WILLIAMS APARTMENTS PLYMOUTH HOUSING GROUP

01 PROJECT OVERVIEW DESIG

DPD PROJECT # 3011476

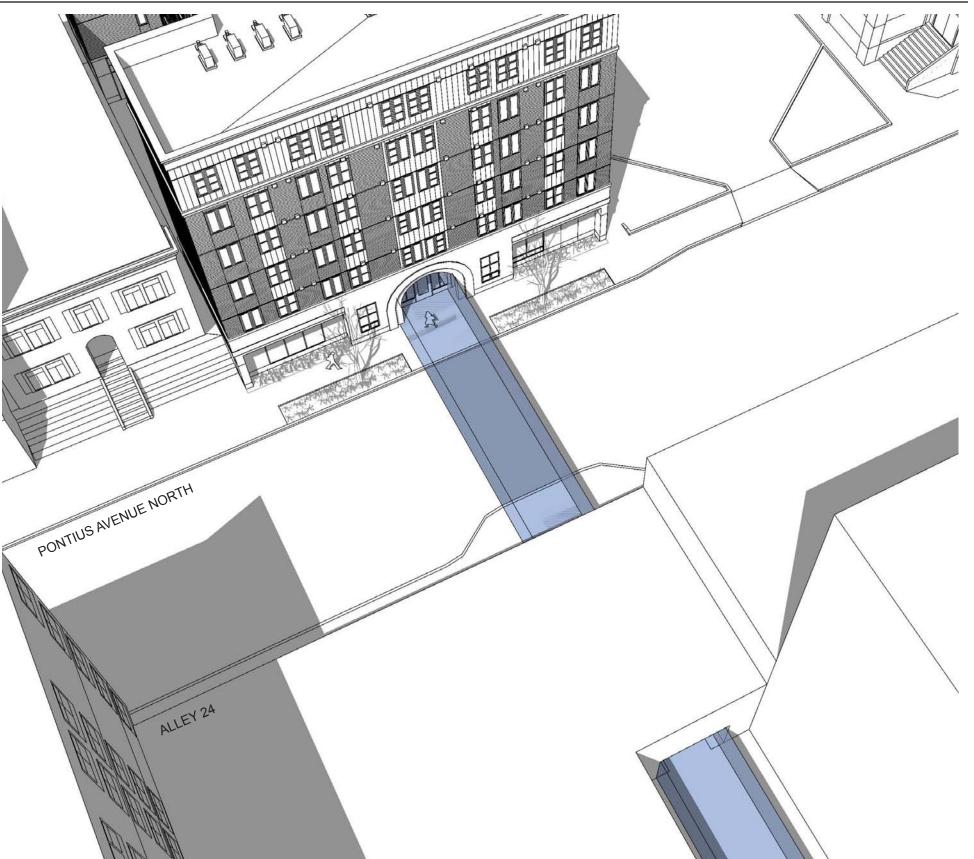
COMMENTS:

"The Board would like the project to respectfully address the wall treatment along the north facade facing the Immanuel Lutheran Church. The applicant and owner will be meeting with the church members to receive comments and coordinate responses to their concerns."

RESPONSE:

The Owner and Design Team met with the Immanuel Lutheran Church (ILC) to review the north elevation and project as a whole. The ILC is pleased with the treatment of the north façade and the opportunity to provide this type of housing. The landscaping along the north property line will be regarded and integrated D-6. Screening of Dumpsters, Utilities, & Service Areas

UPPER LEVEL SETBACK DIAGRAM

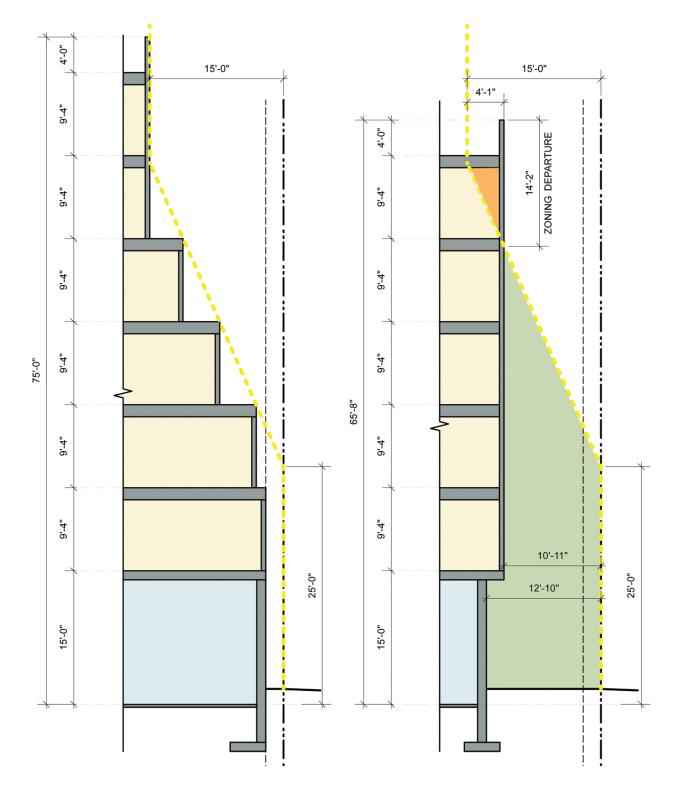
Comment:

The Board supported the requested departure from SMC 23.48.012 in order to modify the amount of required Upper Level Setback along the alley facade.

Response:

Structures on lots abutting an alley in the SM/R designated area As presented in the Early Design Guidance meeting, this debacks shall be provided as follows: regarding the walk-ability and safety of the alley are addressed. private spaces. A staff area is adjacent to the alley with large windows that can be the 'eyes on the alley'. We feel that stepping back the entire building along the alley and providing the ground level amenities are a greater benefit to the neighborhood than stepping back the building at the sixth floor. Other benefits provided by the overall massing of the building are the two courts at the north and south property line. This will allow for daylight to reach the existing apartment building to the south and provide privacy to the units with the distance created between the windows. Along the north property line, the court provides a landscaped area that can be integrated with the Immanuel Lutheran Church and provide daylight to the residential units if the property would be developed in the future. The building is also proposed to be under the allowable height limit by approximately ten feet reducing the impact on the alley.
